MILITARY SPECIFICATION

MODULES, STANDARD ELECTRONIC

DECODER, BINARY, DIGITAL, KEY CODE GDN

This amendment forms a part of MIL-M-28787/7C(EC), dated 7 September 1982, and is approved for use within the Space and Naval Warfare Systems Command, Department of the Navy, and is available for use by all Departments and Agencies of the Department of Defense.

FIGURE 15. Power supply transient rise time test circuit waveforms at table XI.

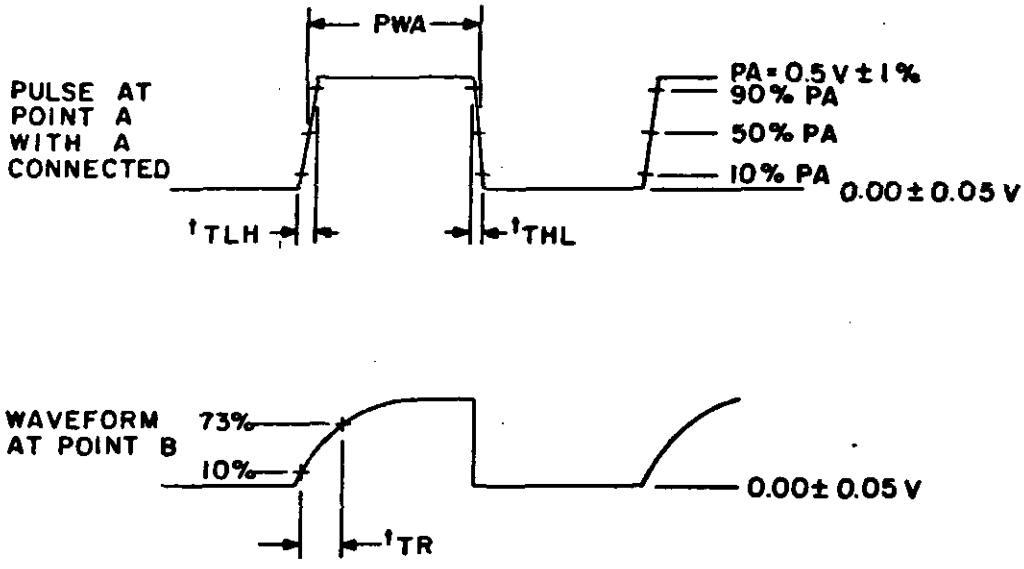
FIGURE 15: Delete and substitute new figure 15 as printed on page 3 of this amendment.

NOTES:
1. Input pulse parameters:
   PWA = 30 µs ±10%.
   $t_{TLH} = t_{THL}$ = 50 ns ±10%.
   PRP = 60 µs ±10%.
2. Measure $t_{TR}$ at point B.
